RS-15-204

Peach Bottom Atomic Power Station, Units 2 and 3
Renewed Facility Operating License Nos. DPR-44 and DPR-56
NRC Docket Nos. 50-277 and 50-278

Subject: Fifth Six-Month Status Report in Response to March 12, 2012 Commission Order Modifying Licenses with Regard to Reliable Spent Fuel Pool Instrumentation (Order Number EA-12-051)

**Fifth Six-Month Status Report for the Implementation of Order EA-12-051, Order
Modifying Licenses with Regard to Reliable Spent Fuel Pool Instrumentation**

Unit 2 - West Side of Spent Fuel Pool

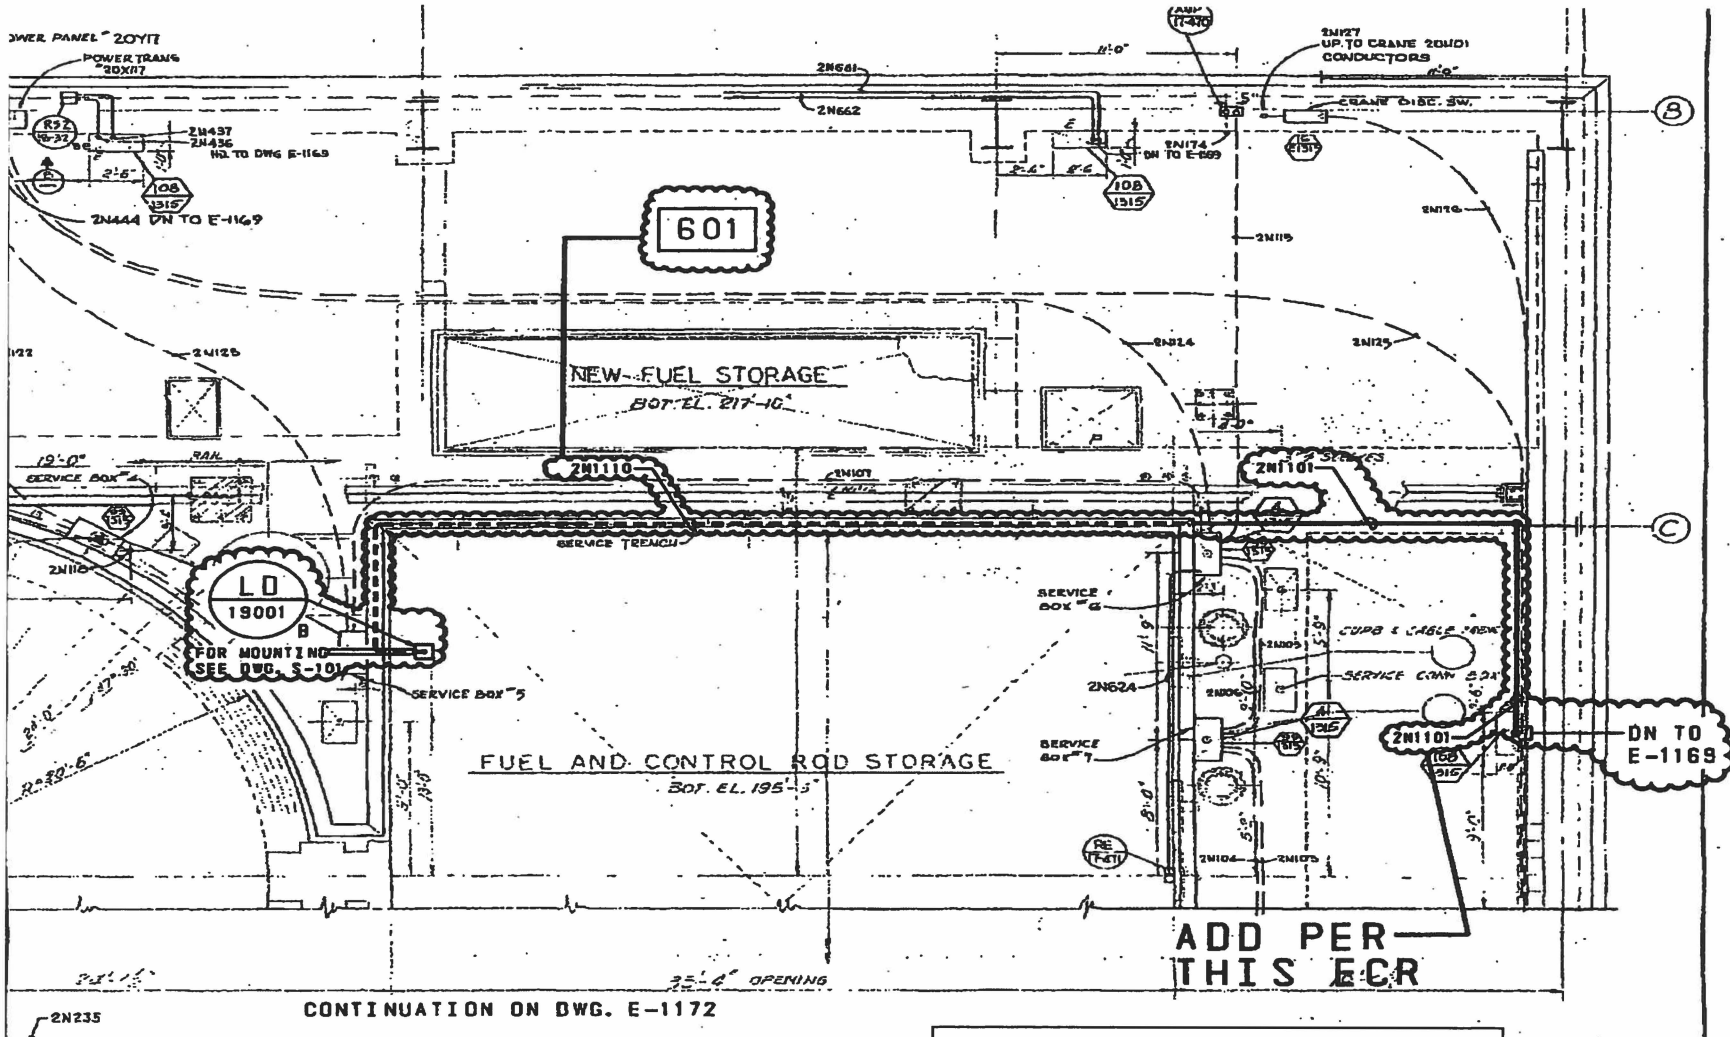
<p style="text-align: center;">3 (RAI-2, Ref.4)</p>	<p><u>RAI Question:</u> Please provide a clearly labeled sketch or marked-up plant drawing of the plan view of the SFP area, depicting the SFP inside dimensions, the planned locations/placement of the primary and backup SFP level sensor, and the proposed routing of the cables that will extend from the sensors toward the location of the read-out/display device.</p>	<p>Complete. Please see Attachment 1 for a sketch which shows the probe locations and drawing markups from the design package which have clouded areas that show the cable/conduit routing on the refuel floor. As shown on Peach Bottom Atomic Power Station drawing S-226, sheet 1, each pool is 35' – 4" in the north-south direction and 40' – 0" in the east-west direction. The sensors are diagonally opposed (north and south) on opposite sides of the pool, which is a distance that is greater than the shortest dimension of the pool.</p>
